CNCL-24-55

Re: Maxwell Village Building Proposal - Report ED-24-42 Revised Applications to Amend Zoning By-law 60-94 and for Approval of a Draft Plan of Subdivision, Icon Harmony Limited, 1081 and 1093 Harmony Road North and 836 Pinecrest Road.

Re: Harmony Road Full Access Review

Location: 1081 and 1093 Harmony Road North and 836 Pinecrest Road, Oshawa, ON
Insured: Jane A. Clark
Your File: Pinecrest Infill Development
Our File: 230914TRA

1 SK.3 VEHICLE TURNING ASSESSMENT - LEFT TURN INTO PRIVATE LANE

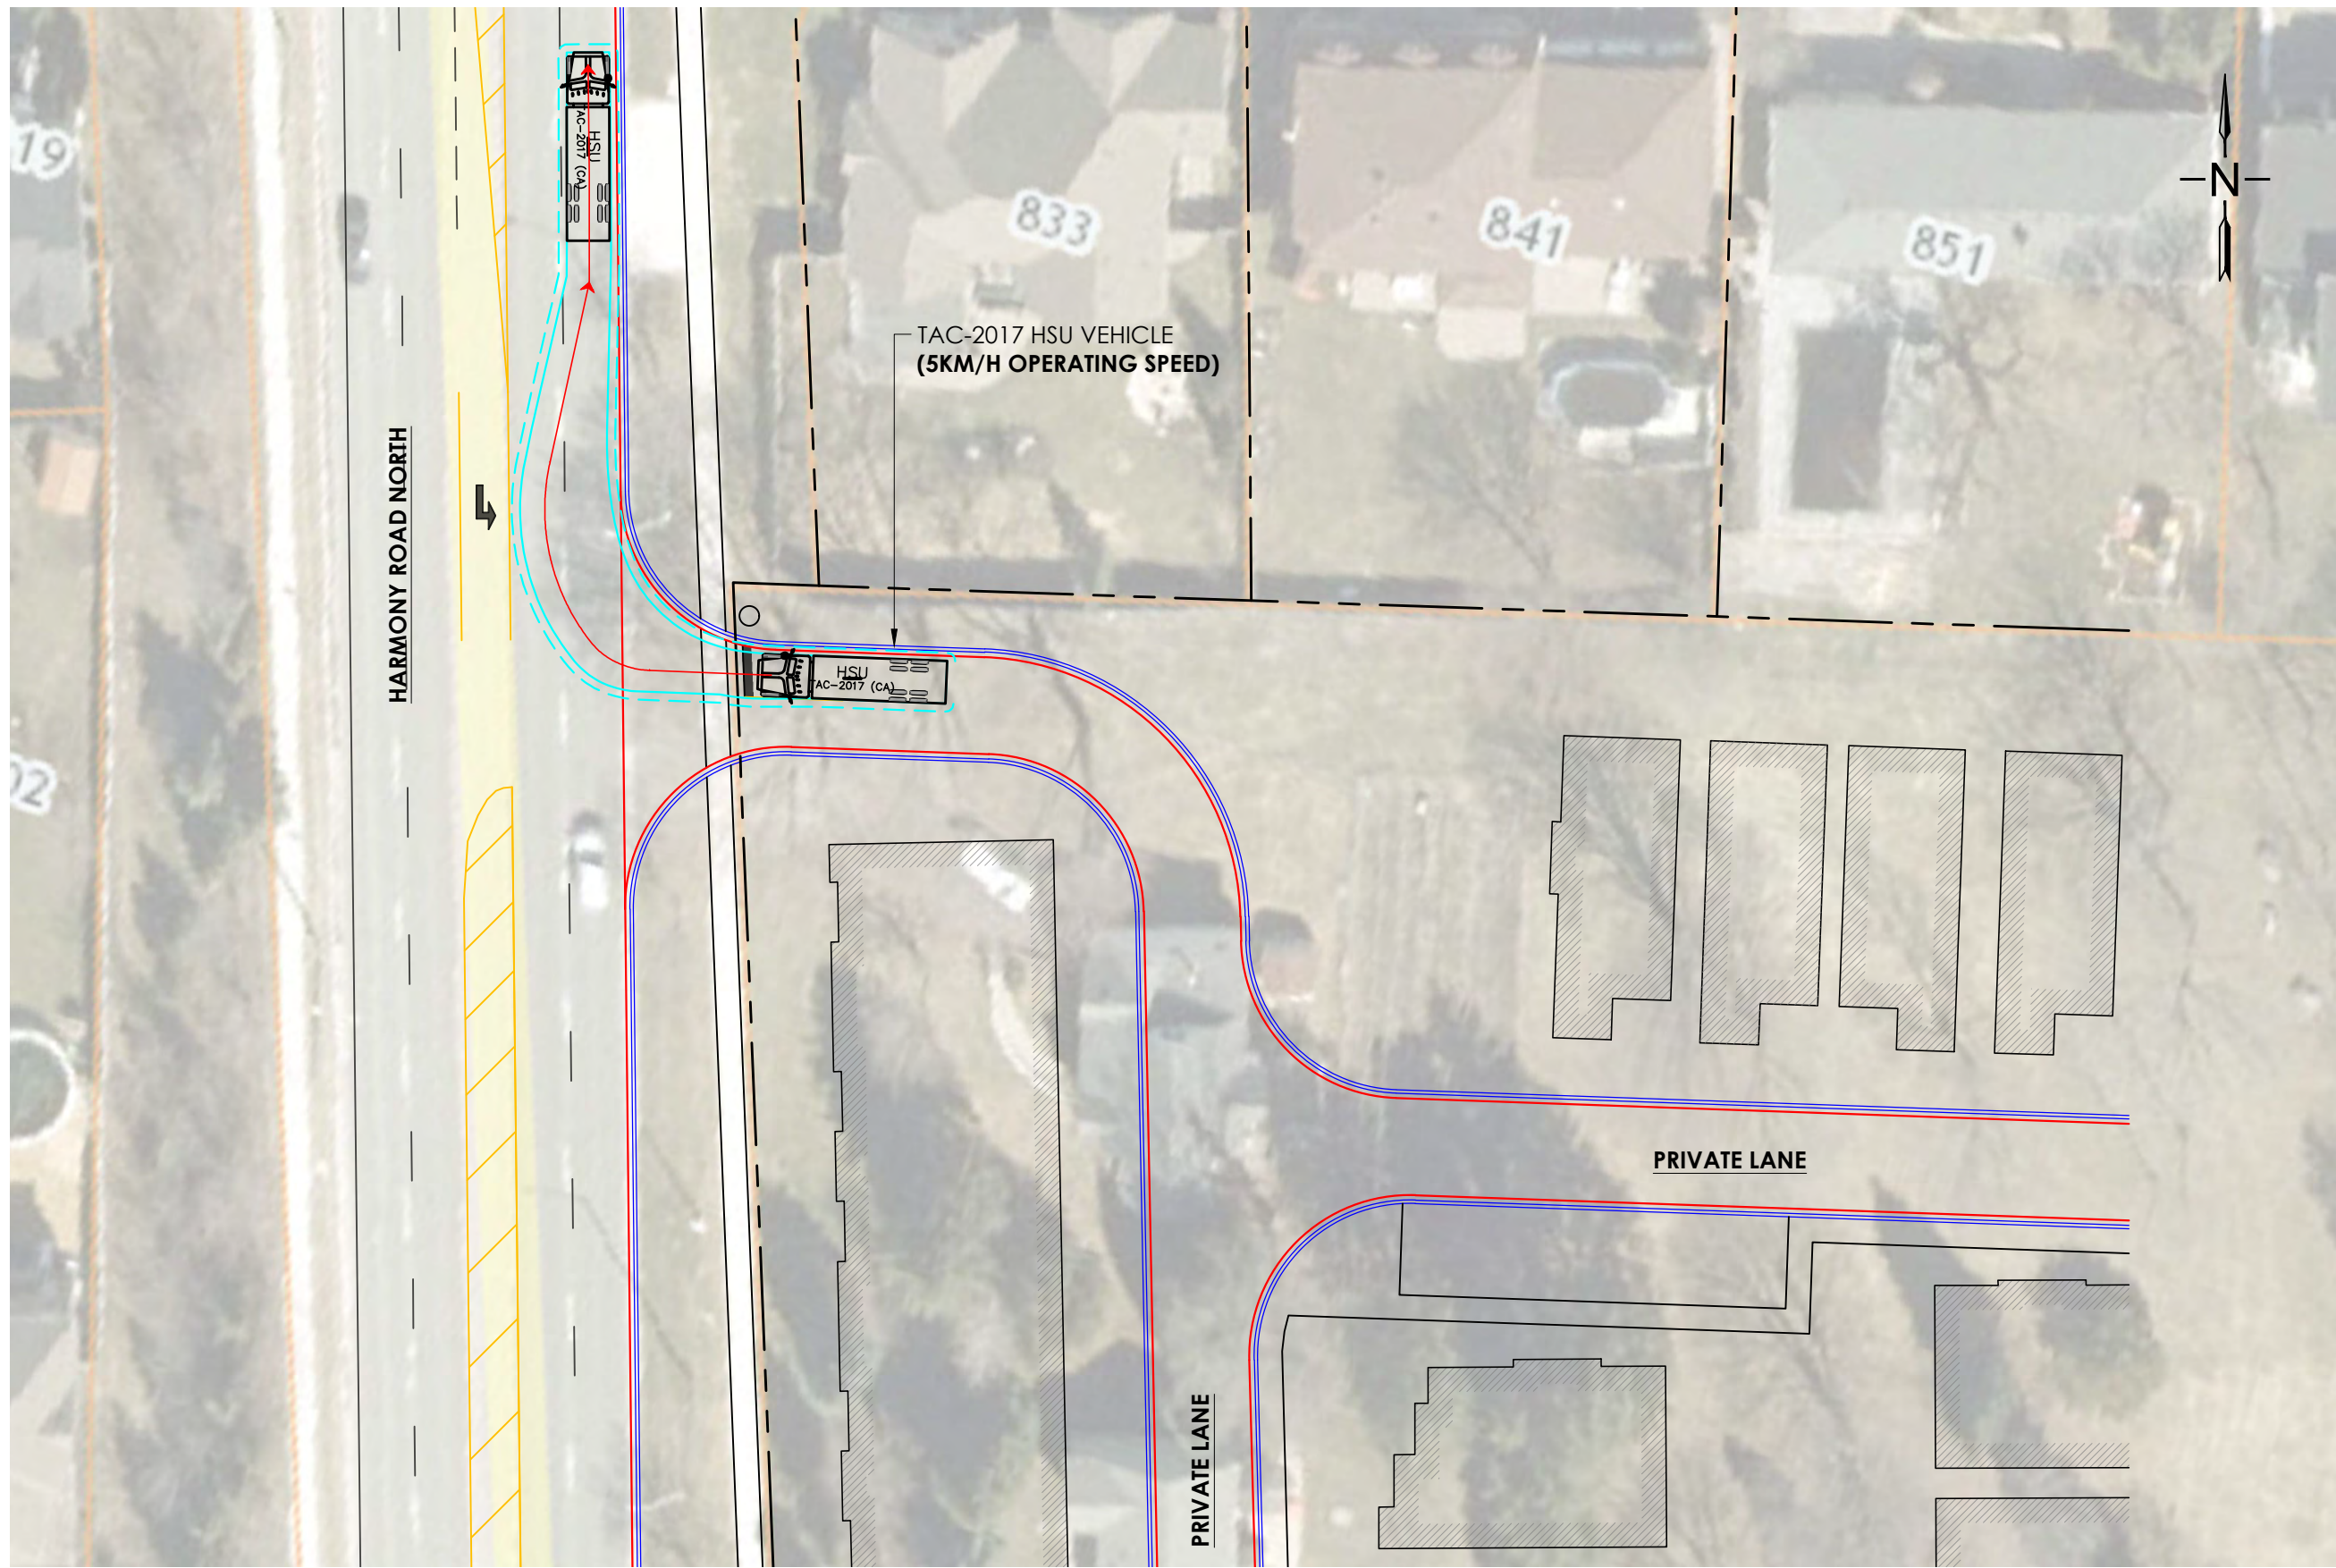
The swept path analysis confirmed that the proposed driveway width (roughly 6.0 meters), corner radius (roughly 9.5 metres), and stop sign location were sufficient to accommodate all critical movement to accommodate the design vehicle. Turning movements provide sufficient safety buffer distance (0.5 metres) from fixed objects, and vehicles are able to turn safely without encroaching on fixed objects such as raised curbs. These turning movements (such as encroaching on opposing lanes on local driveway or roads) are aligned with the provincial allowance for large vehicle movements.
